Historic Zoning Commission

March 20, 2025

Case # HZ-23-165

<u>Description of proposed project:</u> Pool House Revision

PERSPECTIVE VIEWS

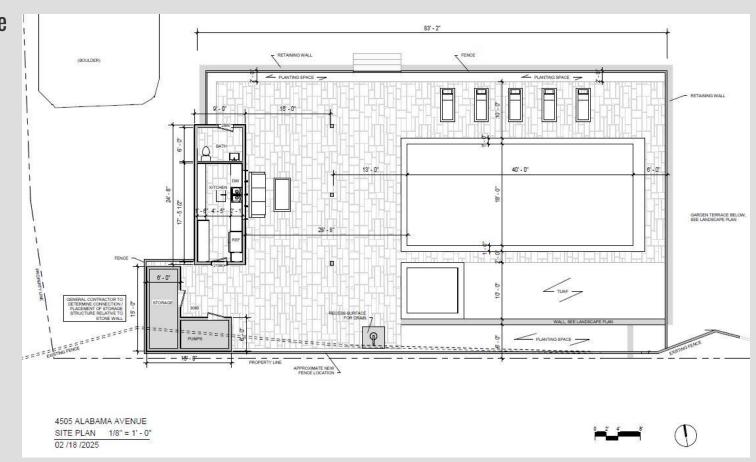
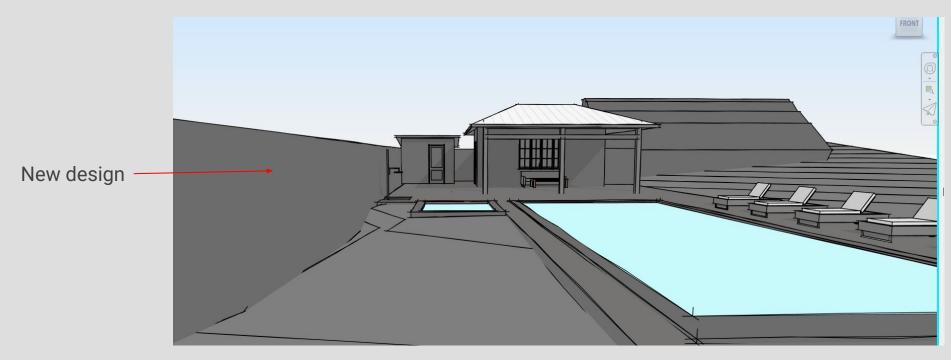
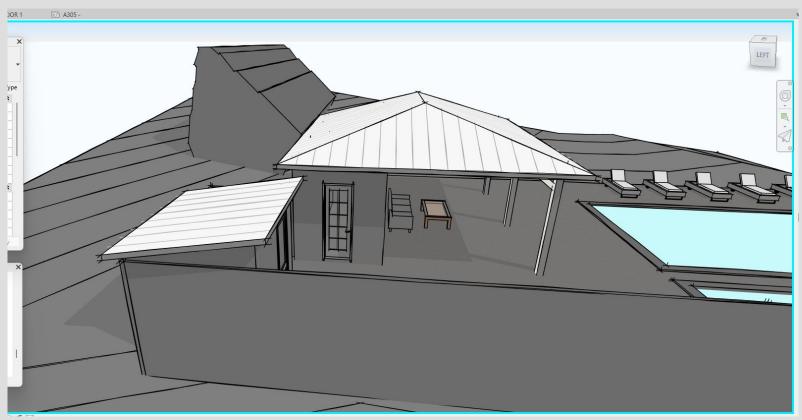
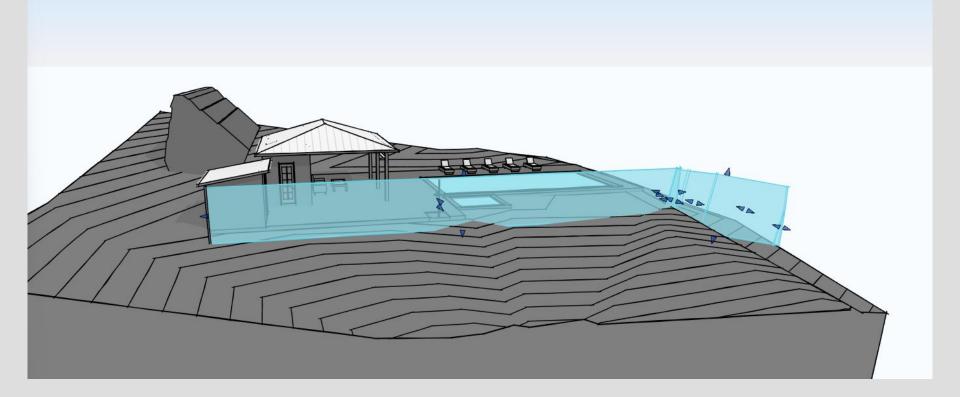
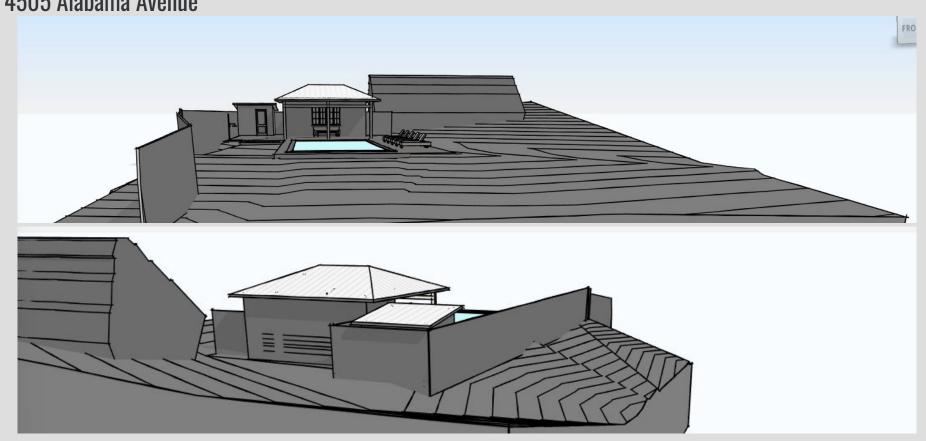
- 1. Smaller in scale than the primary building; Yes. The applicant has added a second storage and pump house structure. The renderings do not match the site plan provided. Applicant to confirm proposed design of the storage and pump house structure.

- 2. Simple in design but reflecting the general character of the primary building. For example, use gable roof forms if the main dwelling has a gable roof, hipped roof forms if the main dwelling has a hipped roof etc.; Yes, simple design and a hipped roof which can be found on the primary dwelling.

- 3. Located as traditional for the street, near an alley or at the side of the dwelling, not close to or attached to the primary building; Yes.
- 4. Compatible in design, shape, materials, and roof shape to the main building. Roof form is hipped which can be found on the primary dwelling.

- 5. Preferably of wood siding. However, if located along rear alleys or towards the rear of the lot, secondary buildings may have exterior siding materials such as masonite (preferred), aluminum, or vinyl. Along rear alleys or rear lot lines, standard prefabricated buildings are also acceptable. The applicant is proposing cement lap siding to match the primary dwelling.

- 6. If readily visible from the street, secondary buildings should have an emphasis on historic designs and detailing. For garages wood paneled doors are more appropriate than paneled doors of vinyl, aluminum, or steel. Wood paneled overhead roll-up doors are widely available and are appropriate for new garages. The pool house is partially visible from Guild Trail.

Case # HZ-25-12 4409 Tennessee Ave.

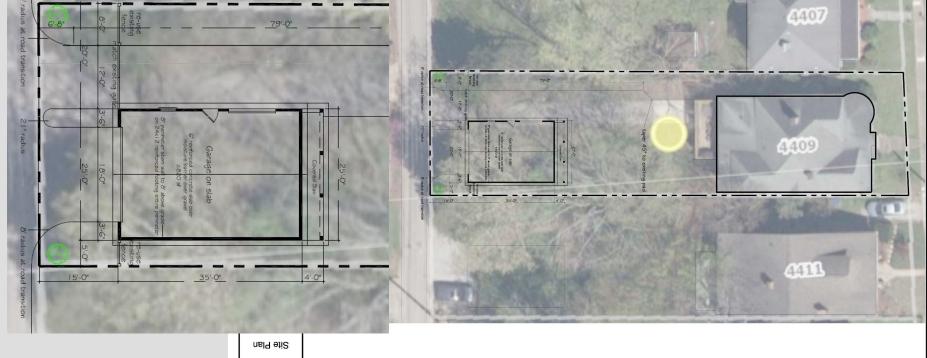
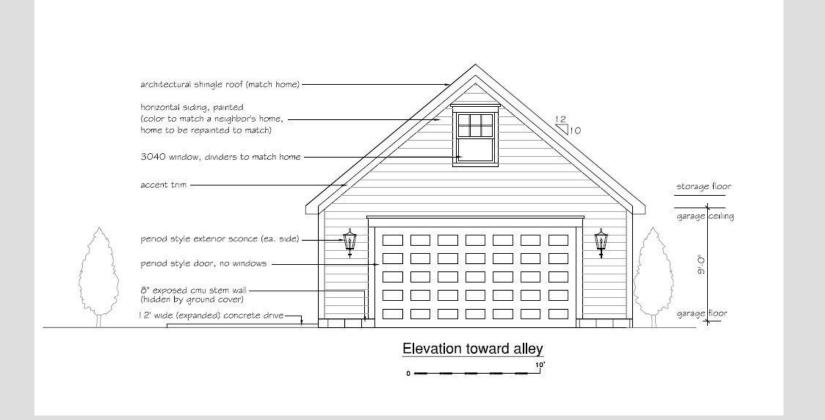
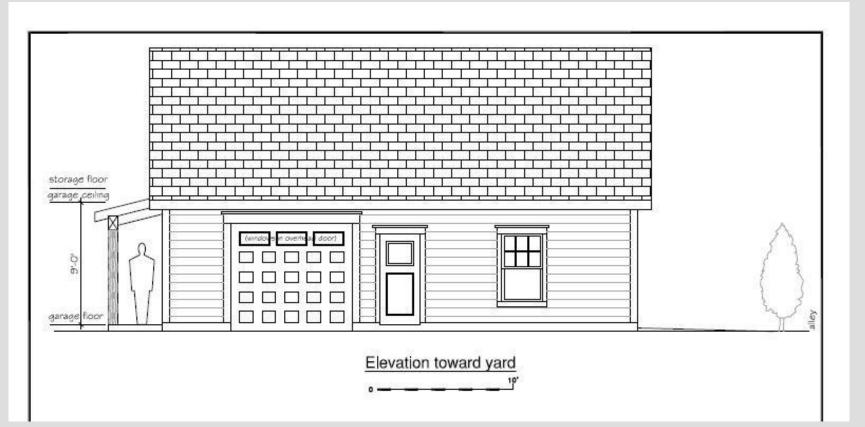
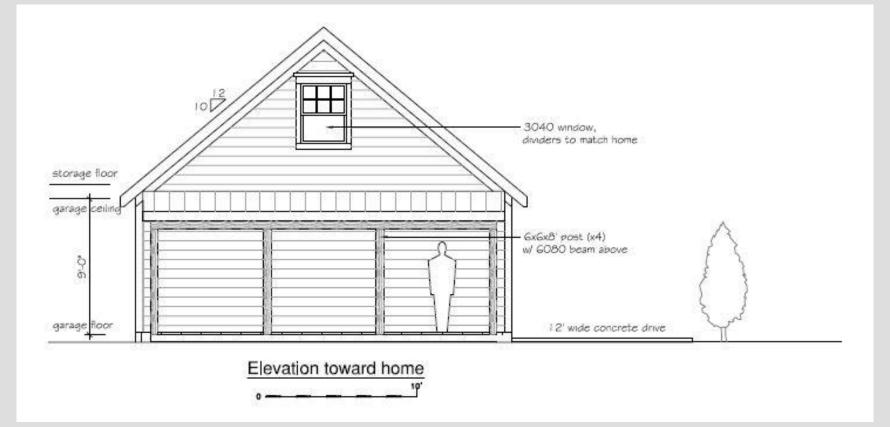
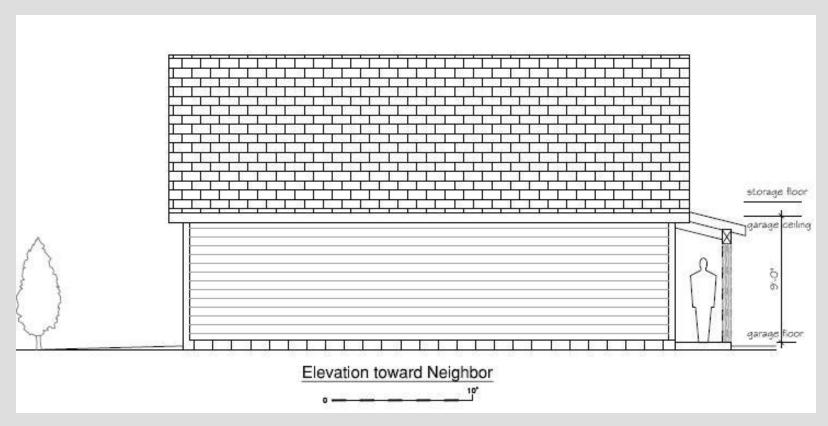
- A. And their original designs, materials, and placement should be preserved.
- B. Which are new, should be located at the rear with access from the alley. The applicant is proposing a new curb cut to the proposed garage and repaving the existing driveway. Both driveways are located off the alley.

- C. In the front or side yards should be of gravel (white or pea gravel), concrete, or concrete tracks (narrow strips). Blacktop or asphalt driveways may be approved but this material is not traditional to the neighborhood and should be avoided. The existing driveway will increase by 2' in width. Both driveways will be concrete.

- D. Should have their parking areas located in the rear yard nearer the alley than the building and screened with hedges, shrubs, or fences where noticeable from the street. The driveways will both be located at the rear off the alley. The yard is currently screened with a fence.

- 1. Smaller in scale than the primary building; Yes.
- 2. Simple in design but reflecting the general character of the primary building. For example, use gable roof forms if the main dwelling has a gable roof, hipped roof forms if the main dwelling has a hipped roof etc.; Yes, the proposed garage has a gable roof like the primary dwelling.

- 5. Preferably of wood siding. However, if located along rear alleys or towards the rear of the lot, secondary buildings may have exterior siding materials such as masonite (preferred), aluminum, or vinyl. Along rear alleys or rear lot lines, standard prefabricated buildings are also acceptable. The applicant is proposing horizontal siding (applicant to confirm material).

- 6. If readily visible from the street, secondary buildings should have an emphasis on historic designs and detailing. For garages wood paneled doors are more appropriate than paneled doors of vinyl, aluminum, or steel. Wood paneled overhead roll-up doors are widely available and are appropriate for new garages. The applicant is proposing "accent trim", "period style" garage door, "period style" sconces, and windows to match the primary dwelling. Applicant to confirm materials and detailing for overhead doors and lighting.

____FINERTY-BUTTS RESIDENCE

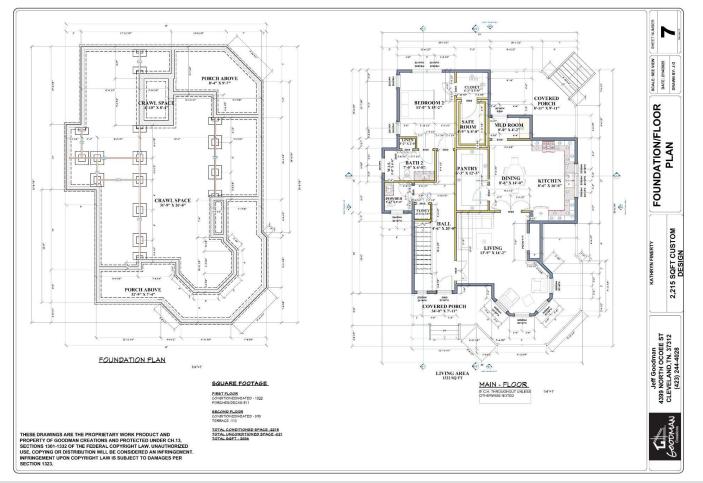
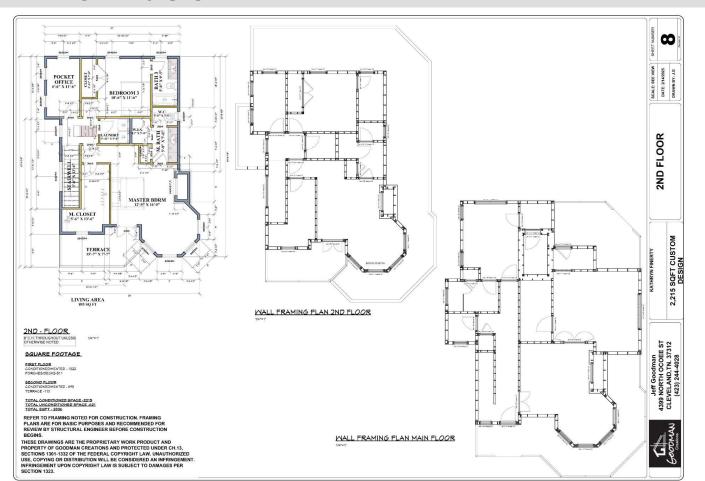
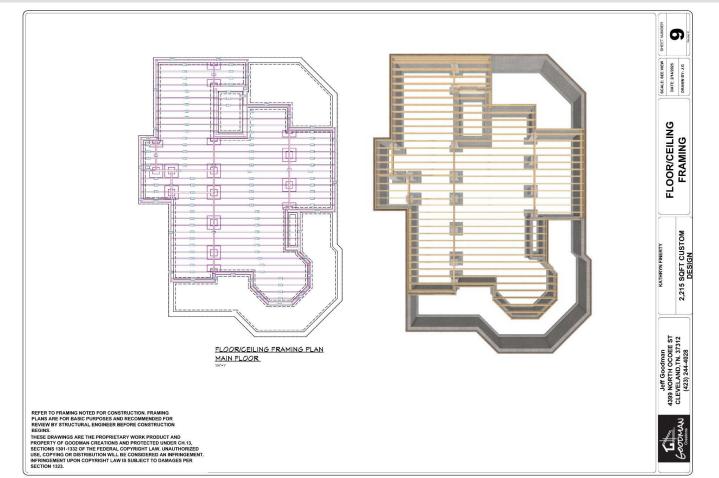
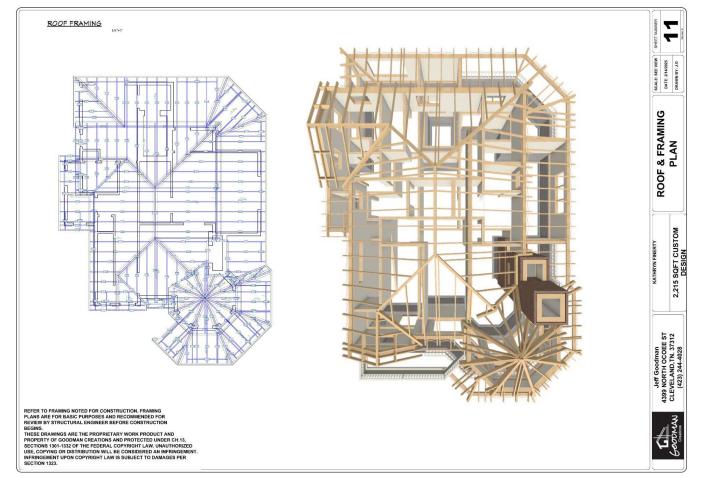
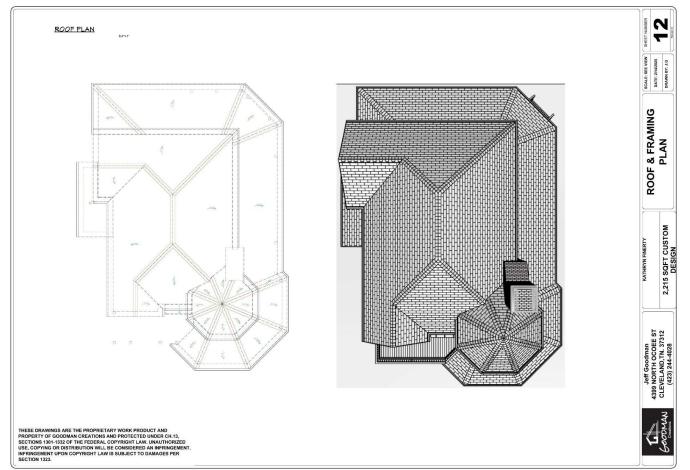
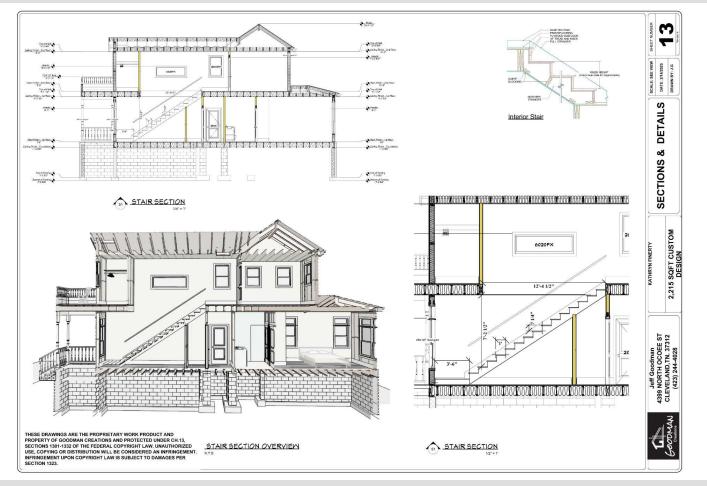
1. Shape. Variations of rectangular and square forms are most appropriate for the district; The applicant is proposing a turret.
 - 2. Scale (height and width). Most of the district is zoned R-2 which restricts new construction to no more than two-and-one half stories or thirty-five feet in height. This maximum height would be appropriate for most blocks in the district. On blocks which have predominantly one-story buildings, new construction of one-to two stories would be more appropriate; The applicant is proposing a two-story dwelling. There are primarily one-story dwellings on Beulah Avenue in this block. The site is at the corner and across from a commercial development.

- 3. Roof shape and pitch. Roof slope ratio for new construction should be a minimum of 6:12 to a maximum of 12:12 (6:12 refers to six inches of rise to 12 inches of run in measuring slopes). Roof for of gable and hipped variations are more appropriate than those of flat, mansard, or gambrel forms. Flat roofs are appropriate only for commercial buildings; The building has a mix of 10:12, 8:12, and 3:12 slopes. The house has a mix of gable, shed, and a hipped conical roof on the turret.

5. Location and proportion of porches, entrances, windows, and divisional bays. Porches should have roof forms of gable or shed design and at least cover the entrance. The proposed porch has a shed roof and covers the entrance. A portion of the porch over the front door has a second story porch with a balustrade.

Porches which extend partially or fully across the main façade are recommended. Porch columns and railings should be simple in design in square or round shapes. Columns should be a minimum of six inches and a maximum of ten inches square or in diameter. Porch railings should have balusters which are no more than two inches square or in diameter. The proposed porch extends fully across the main facade. The porch has turned spindle balusters and columns.

New windows should be rectangular sash whose proportions on the main façade should not exceed three-to-one in a height to width ratio or be any less than two to one in height-to-width (two to one proportions are preferred). No horizontal sash, casement, or awning type windows should be placed on the fronts of buildings. The use of plastic or "snap-in" muntins (window pane dividers) is discouraged. 1/1 aluminum clad windows with transoms are proposed on the first floor. The second floor has appears to have 1/1 aluminum clad windows.

- 6. Foundation height. Height of foundations should be a minimum of 1 foot, six inches and a maximum of two feet above grade. No slab. Foundations or at-grade foundations should be utilized on the fronts or readily visible sides of buildings. The foundation will be clad with brick and 2' from finished grade.
- 7. Floor-to-ceiling heights. Floor to ceiling heights should not exceed ten feet and not be less than eight feet;
- 8. Porch height and depth. Porch heights should be consistent with those of adjacent buildings. Porch depths should be a minimum of six feet; The porch depth is 7'.

Frame Dwellings: If the <u>new construction is of frame</u>, the <u>preferred exterior material is horizontal wood siding which is a minimum of four inches and a maximum of six inches in width.</u> The use of masonite is also acceptable as long as it meets these size recommendations. The use of grained pressboard or chipboard is less appropriate but is acceptable if it meets these size recommendations. Vertical board siding is not appropriate for new construction on the fronts or sides of buildings. The use of vinyl or aluminum siding is also discouraged and should only be used on rear or non-readily visible sides of buildings. The applicant is proposing 7 ¼ hardie lap siding.

- 10. Details and texture. The width of window and door trim should be at least three and one-half inches. Roof eaves should have a minimum depth of eight inches. No imitative architectural features such as vergeboard ("gingerbread"), roof balustrades, or prominent stained glass windows are appropriate for new construction. The window trim will be 1x4 and 1x6. The applicant has proposed a second story on part of the front porch with a balustrade.

- 11. Placement on the lot. Front and side yard setbacks should respect the setbacks found along the block on which the building is sited. The minimum front yard setback under R-2 zoning is 25 feet. Requirements for side yard setbacks are a minimum of 10 feet. The applicant is showing a 20' front setback (14' at the edge of porch) and 6'3" side setbacks. The width of the building has been reduced from 52' to 51'. The applicant has reduced the width of the second story to 47'.
